DOOSAN **Document Transmittal** Upper Trishuli-1 HEP (216MW)		Date 2022-06-08	DT No.: UT1-HEP-DHI-PC-D-0035	SHEET 1 OF 1
DOOSAN NEPAL BRANCH OFFICE	Address & Contact No. : Four Square Building, Naxal, Kathmandu, Nepal (P.O Box : 1387) + 977 1 692 3014	Project No. H20002	DOCUMENT DISPATCHED BY Courier Service ☐ Messenger ☐ Post-Air Freight ☐ Document System or E-mail ■ By hand ■	
DOCUMENT DISTRIBUTION	■ POWER CHINA (Subcontractor) ☐ Doosan's Site Office			
SUBJECT	Review Note RN-0136_Excavation and Support Drawings of Headrace Tunnel

REVIEW NOTE

Contractor	**Doosan Enerbility**		
Title of the Document	Excavation and Support Drawings of Headrace Tunnel		
Document No.	UT1-C-150-CVL-DC-54002	Revision	0A
Date of Documents	31.05.2022	Received Date	02.06.2022
Transmittal Form No.	UT1-HEP-DHI-D-0253		
Previous Review Date/Status	N/A	Prev. Review Note No.	N/A
Review Note No.	**RN-0136**	**Present Review Date**	**07.06.2022**
		Present Review Status	**AN**

Drawing No. UT1-C-150-CVL-DC-54002 (sh. 8/10), version 0A

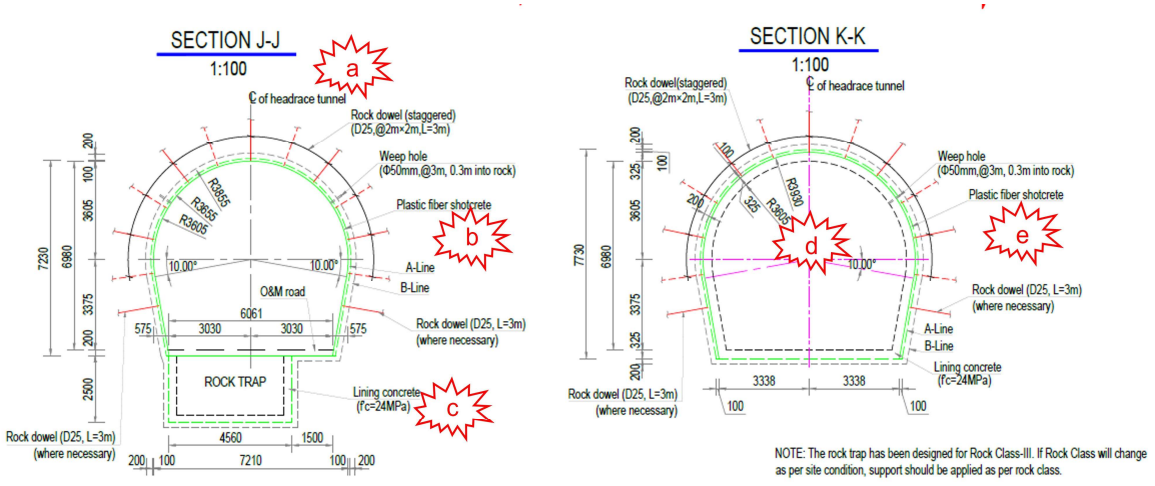
(a) Clearly specify respective rock class.
(b) Provide thickness of shotcrete.
(c) Rock trap must extend also over entire width of tunnel in the downstream end of trap. Consider. Specify that concrete liner is reinforced.
(d) Thickness of reinforced concrete only 150 mm? Clarify both, thickness of shotcrete and thickness of reinforced concrete.
(e) Clearly specify thickness of shotcrete and reinforced concrete for

Drawing No. UT1-C-150-CVL-DC-54002 (sh. 9/10 and 10/10), version 0A

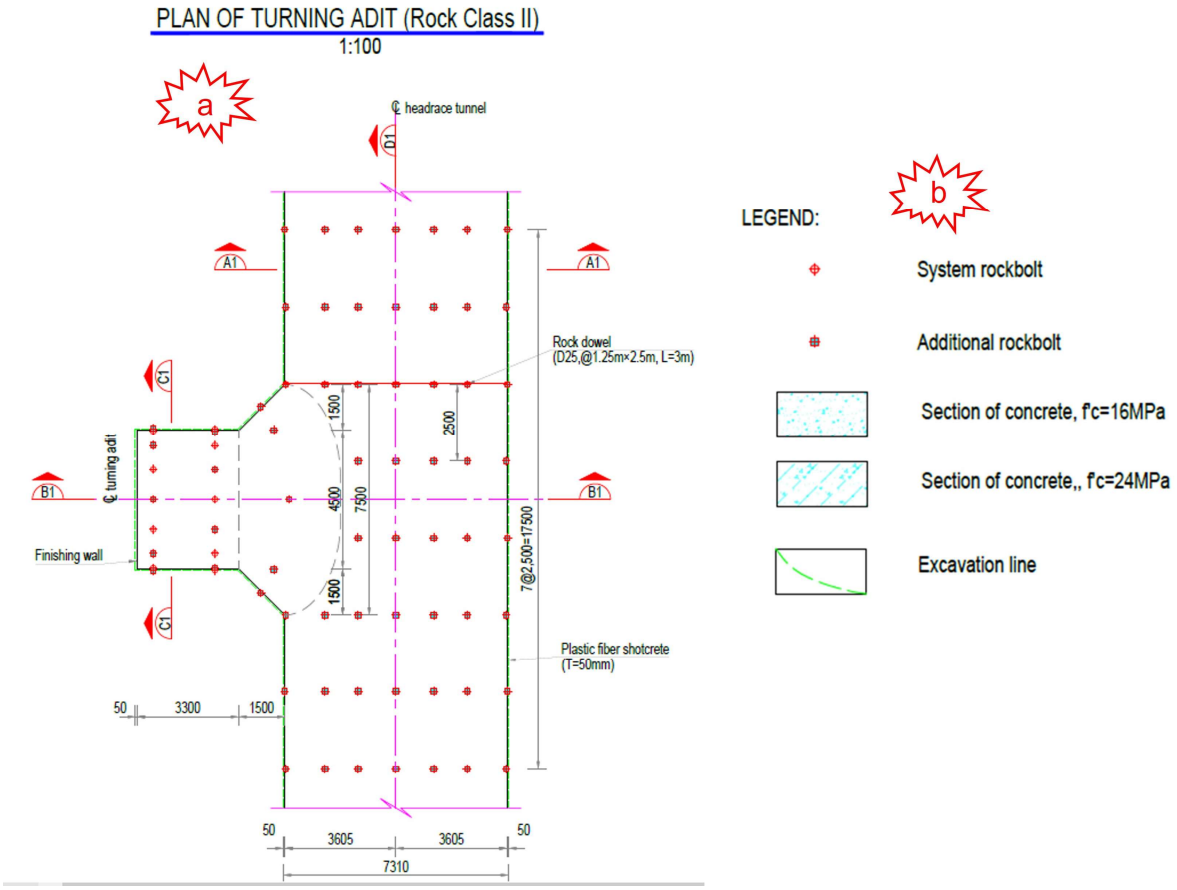
(a) Clarify that Class II rock requires Class III support in turning bays, and Class II rock requires Class III support.

(b) No concrete liner shown in the drawings, but in legend. Clarify.
